To: Economic Development Queensland

Project: Aura Precinct 18 First Development Application

Reference: Response to Informal Information Request – Flood Impact

Figure 1 Site Context Plan Overlaid with Regional Flood Extents

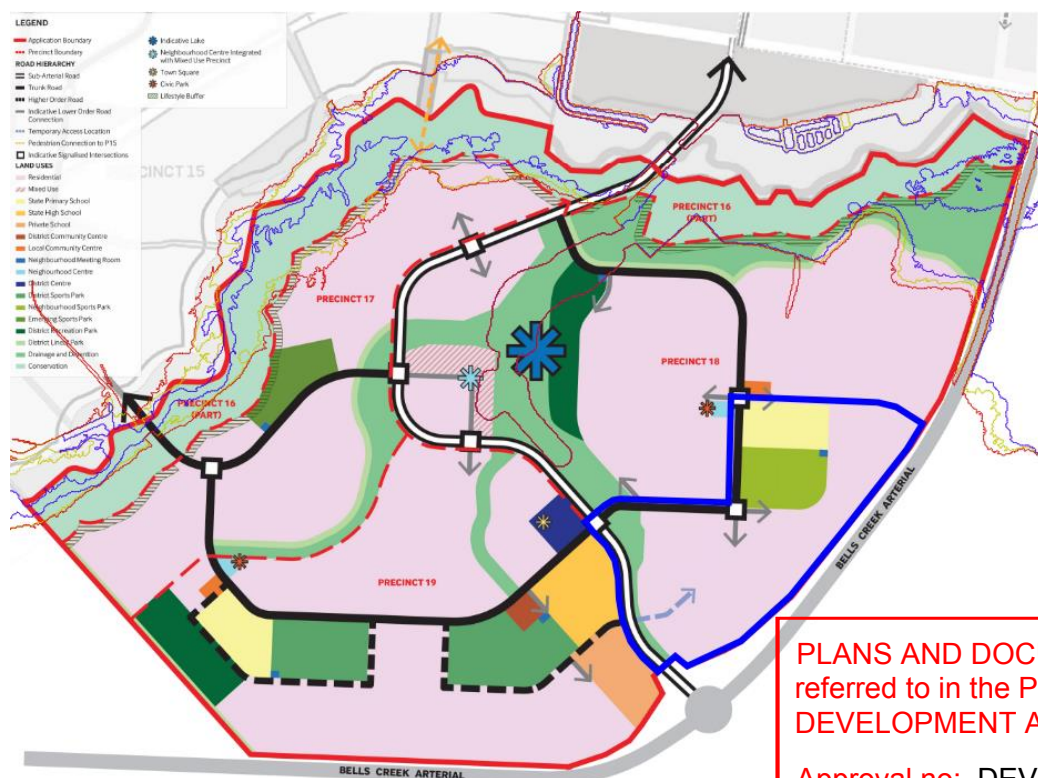
Economic Development Queensland has raised an informal information request regarding the impact of the proposed development works upon regional flooding. The intent of this technical memo is to provide an overview of the interaction of the proposed development works with regional flooding extents and provide guidelines on further investigation to be triggered at such time that development works are detailed within flood impacted site areas.

The overlay of the overall site context plan with the currently approved regional flood levels is shown in Figure 1 below.

The site area associated with the development works within the first development application (outlined in blue), are confirmed to be outside of the footprint of the regional flooding events.

All other development works reflected in the context plan shall be designed in order to achieve no net impacts to regional flooding considerations in line with the existing strategy documents. At such time that detailed design development is progressed within stormwater conveyance areas, central lake and recreation park areas and site areas which are within the footprint of the regional flood events. A review and verification of flood impacts will be completed in order to ensure that no impact to flooding conditions is maintained.

It is noted that a detailed flood assessment will be undertaken in line with the second development application associated with the Precinct 17-19 area, at which time further detail regarding stormwater flow paths will be able to be provided.

Figure 2 Site Context Plan Overlaid with Regional Flood Extents

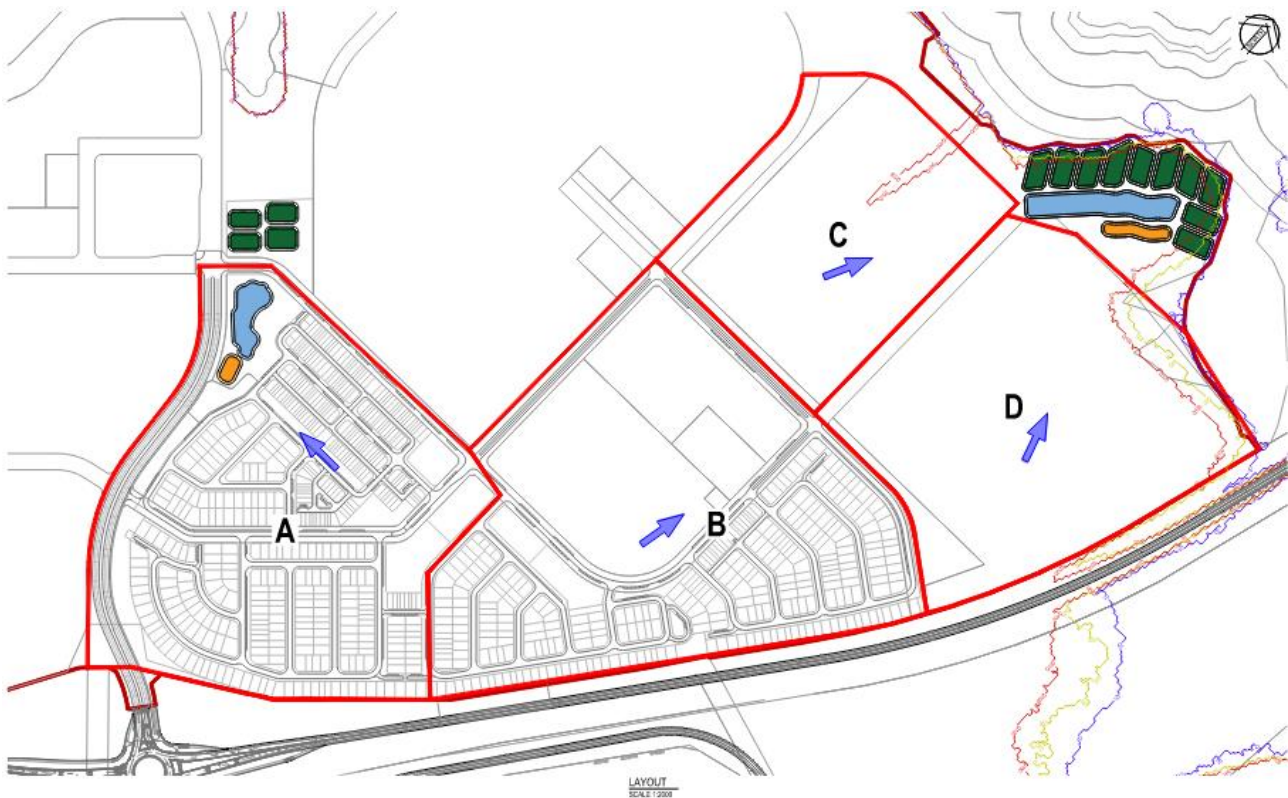
In accordance with Stantec engineering sketch 304701171-100-CD-SK1300 and Figure 2 below, the proposed development site will be serviced by 2 proposed stormwater management devices.

Catchment A of the development will discharge to the northeast towards a treatment device located adjacent a local parkland space. This device does not interact with regional flooding extents.

Catchment B, as well as future development catchments C and D, will discharge towards the northern boundary of the site. The stormwater outflows will be treated by an end-of-line stormwater treatment device located generally as per Figure 2 below.

At such time that that detailed engineering design of the Catchment B-D stormwater treatment device is designed, a review of the regional flooding model shall be completed in order to ensure no impactation to regional flooding considerations.
